Application for Works Approval

Works Approval Number W6316/2019/1

Applicant Silver Lake (Integra) Pty Ltd

Premises Salt Creek Processing Facility TSF2
Mount Monger Road
EMU FLAT WA 6431
Being Mining Tenements M25/347 and L25/31

Figure 2: Location of the tailing/return water pipeline (shown in purple).

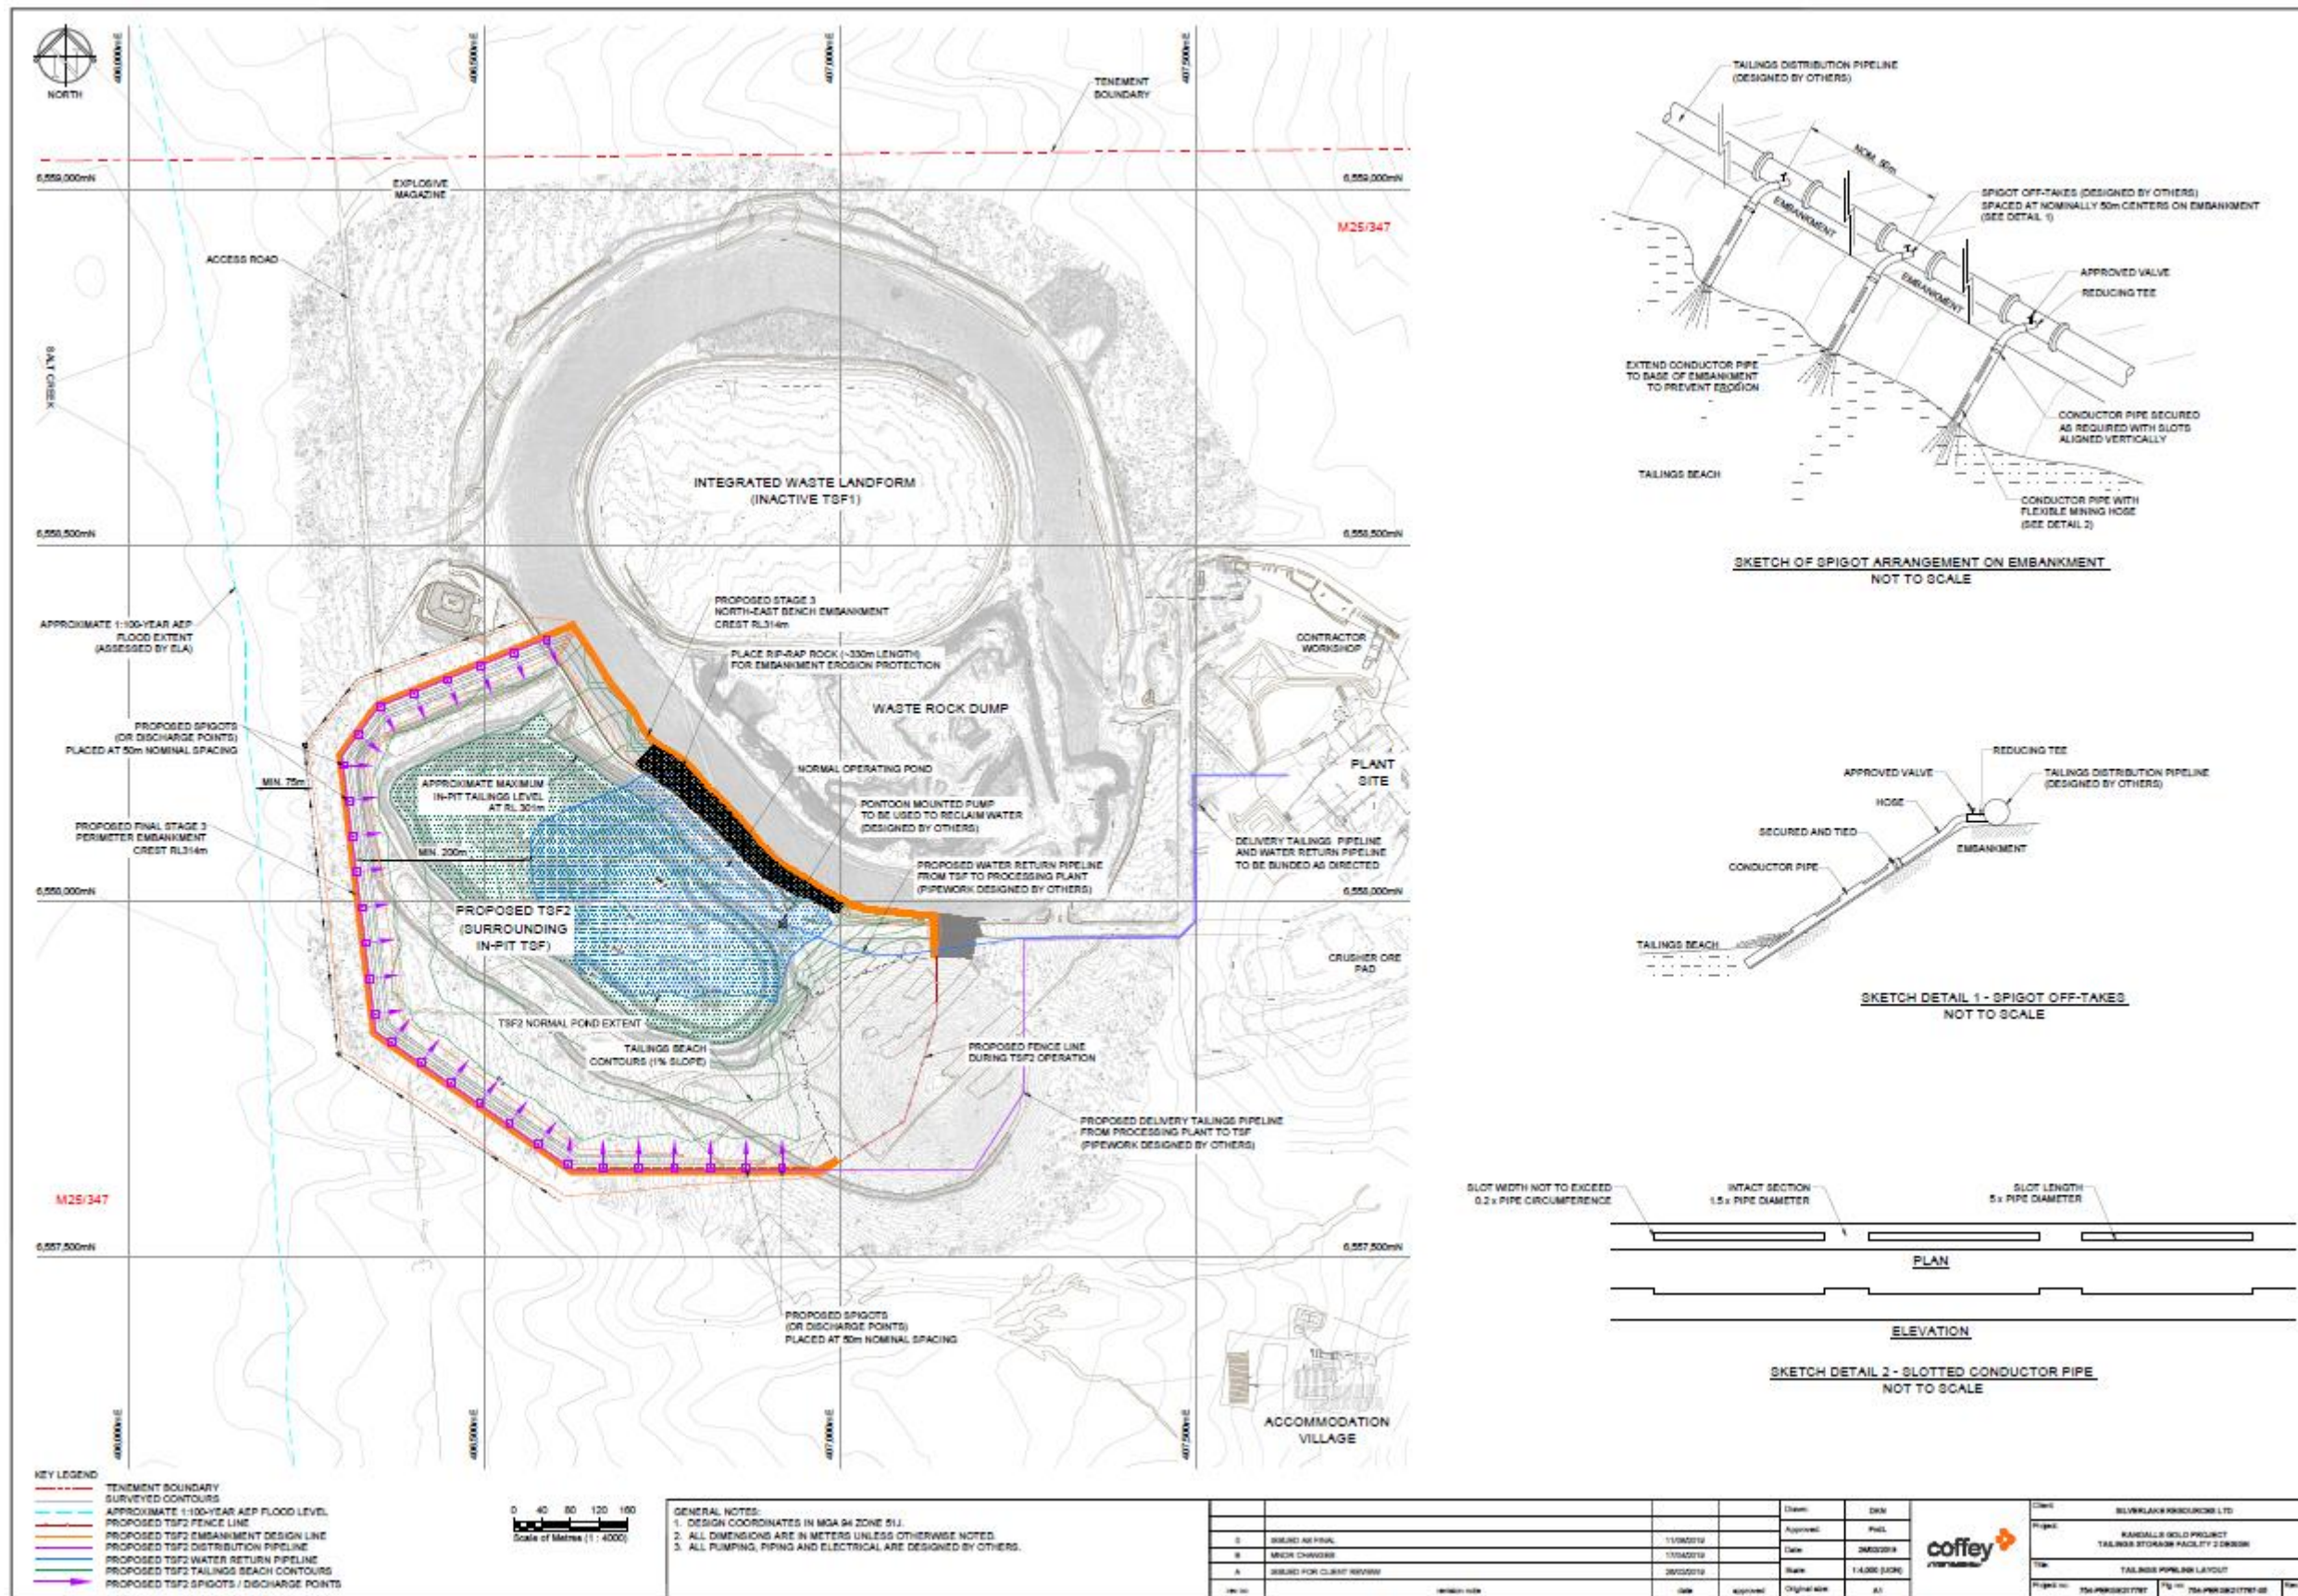
Figure 2 outlines the route (in purple) from the processing plant to TSF2.

1. Tailings solids contain metals/metalloids, have a WAD cyanide concentration between 64-122 mg/L and a TDS of approximately 219,000 mg/L.
2. Supernatant water (return water) has is hypersaline (TDS approximately 145,600 mg/L).
3. All pipelines will be contained within an earthen bund with scour pits. Tailings pipelines will be fitted with telemetry and return water pipeline will be fitted with a flow meter. Control room to monitor flow rates and pressure losses to enable rapid shutdown (not automatic).
4. Pipelines will be inspected for leaks daily.

Existing licence condition 1.2.1 provide adequate regulatory controls for the operation of TSF2 pipelines.

Figure 3: Location of existing (red) and new (blue) groundwater monitoring bores.

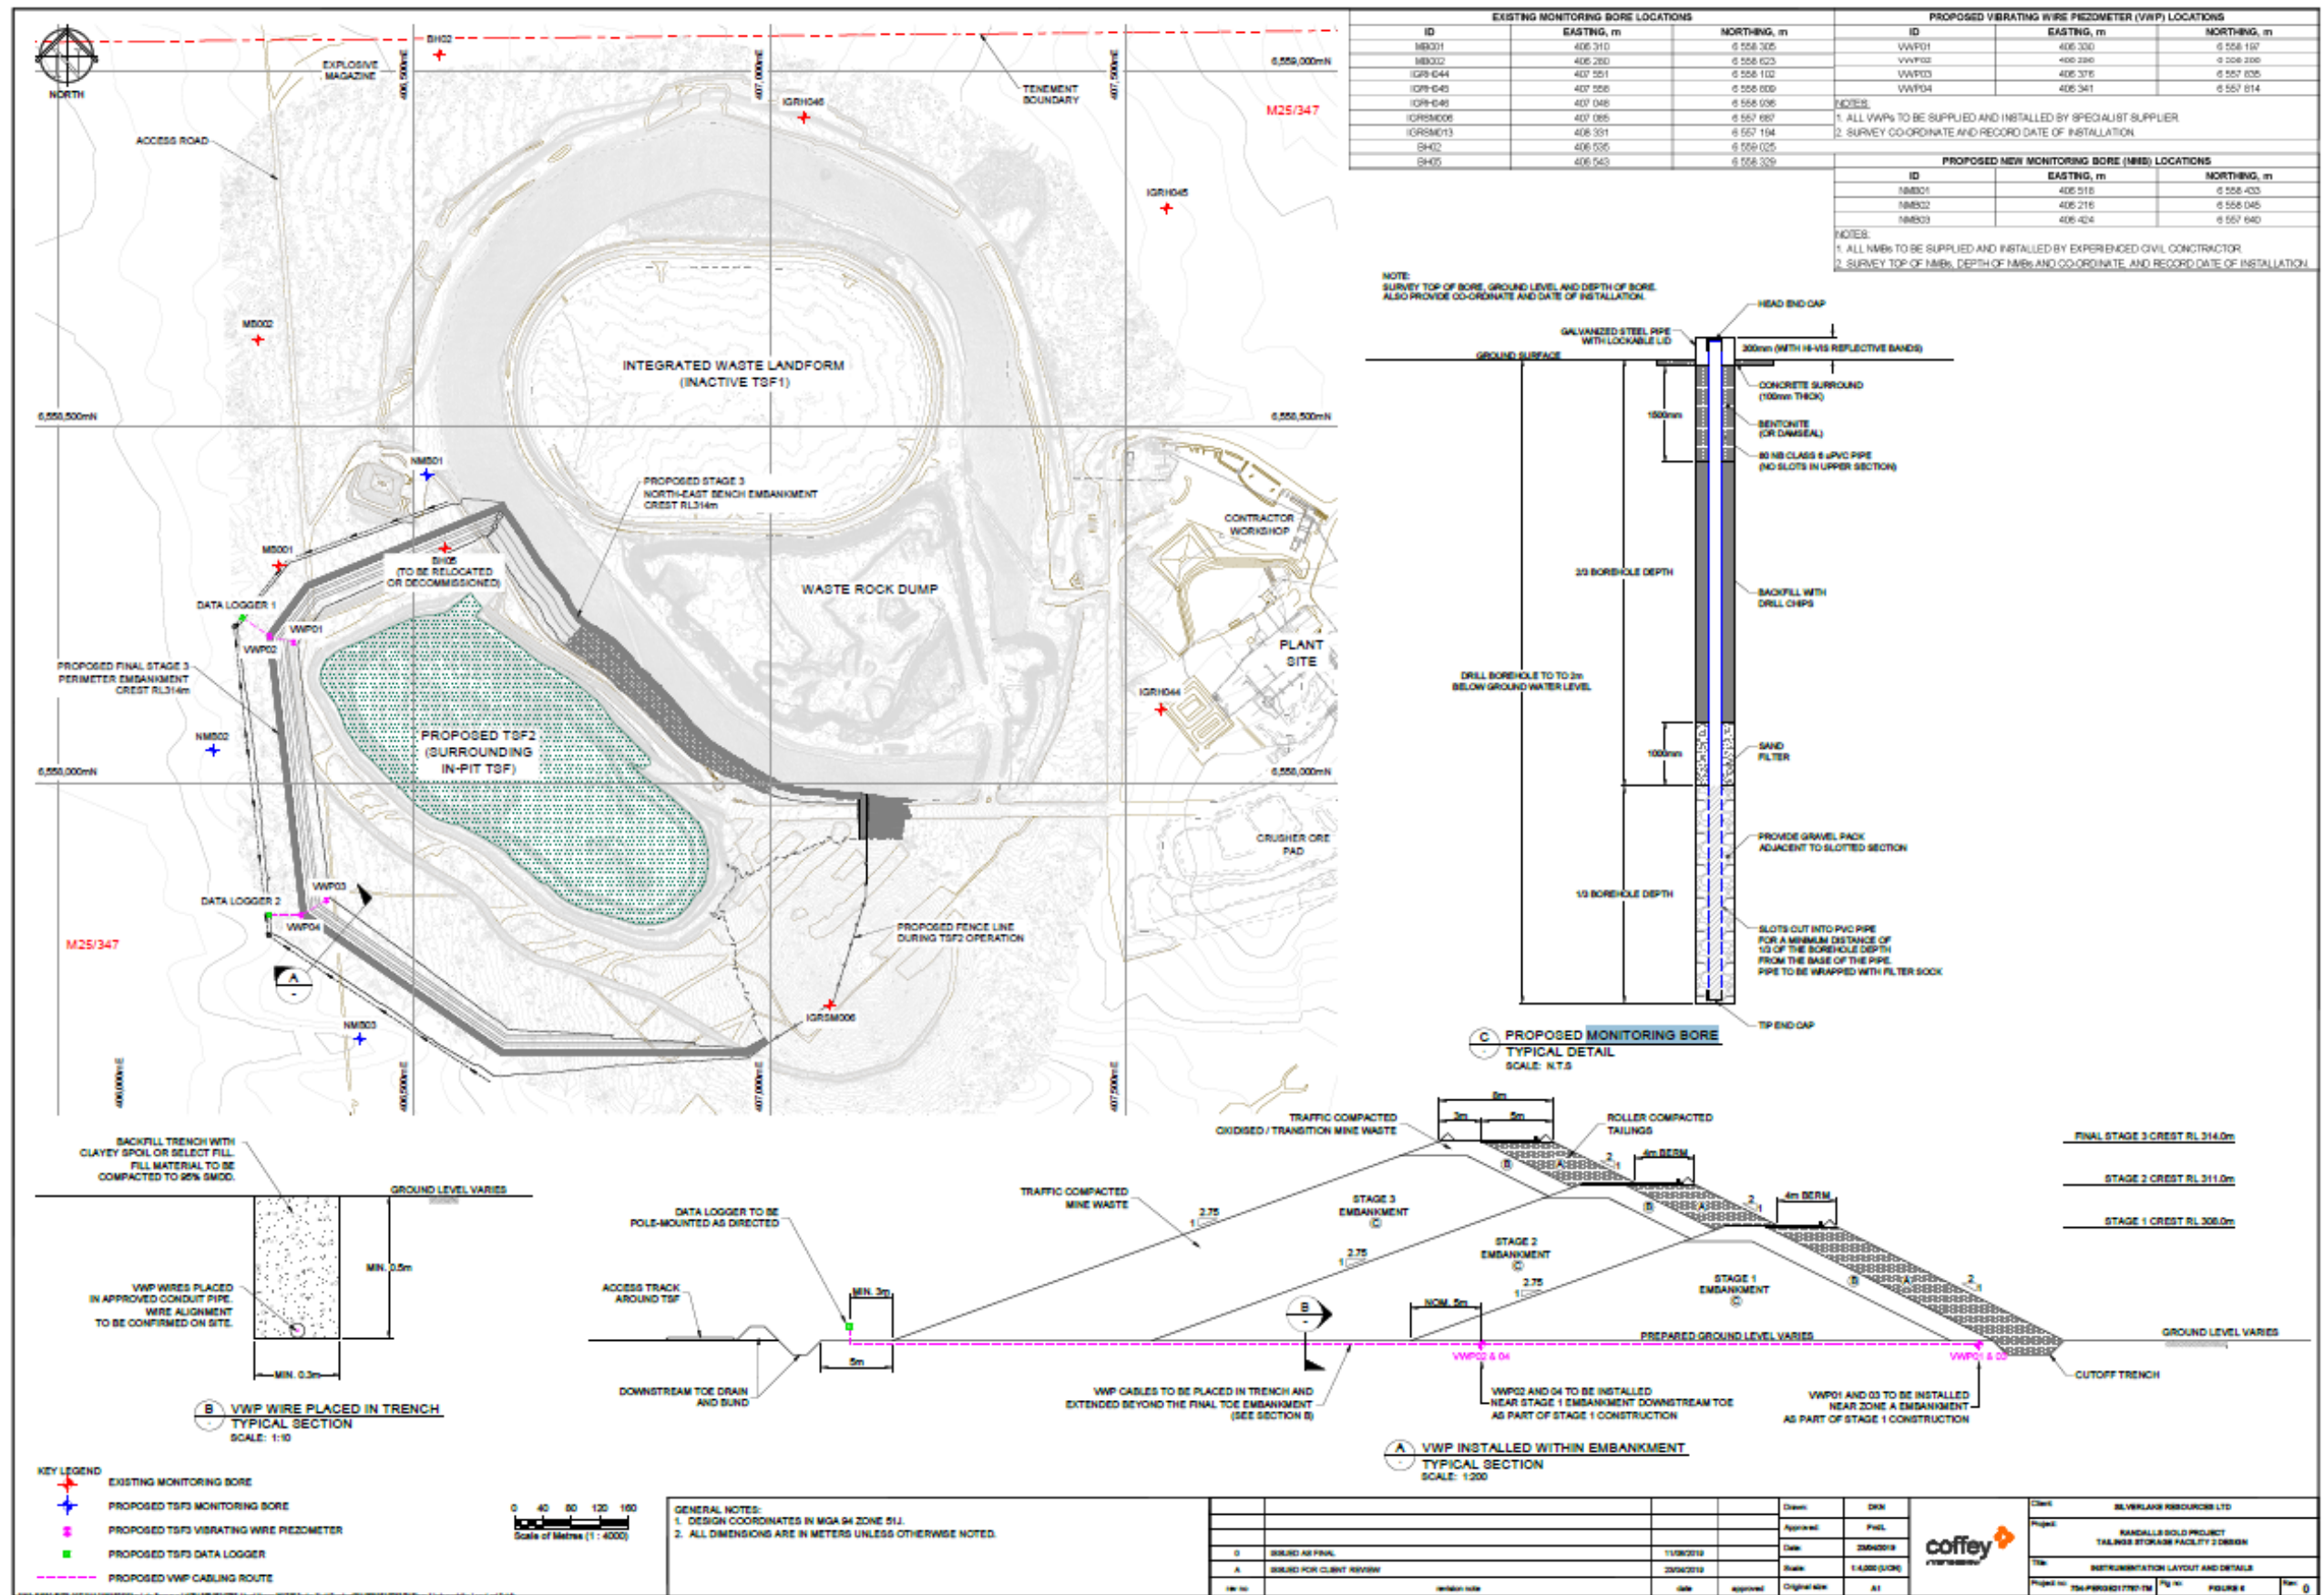
The groundwater mounding assessment has not taken into account the shallower groundwater levels north of the TSF2 location where the TSF2 footprint butts up against the IWL TSF. Groundwater levels here are approximately 5-6mbgl. The groundwater mounding model assumes a SWL of 14mbgl so may not accurately represent groundwater levels surrounding all sections of the proposed TSF2. Therefore there is the potential for groundwater levels to exceed the licences groundwater SWL limit of 4mbgl. In the event of this happening the Applicant has committed to developing a groundwater recovery plan.

To address this possibility conditions will be placed on the licence to implement a target of 6mbgl for standing water levels surrounding TSF2. A condition will also be added to ensure actions to reduce SWL will take place if the target is exceeded. A condition requiring monitoring of the vegetation surrounding TSF2 will also be added to the licence.

A target SWL of 6 meters will be added to the licence. Conditions requiring specific management actions to reduce SWLs if this target is exceeded will also be added to the licence.
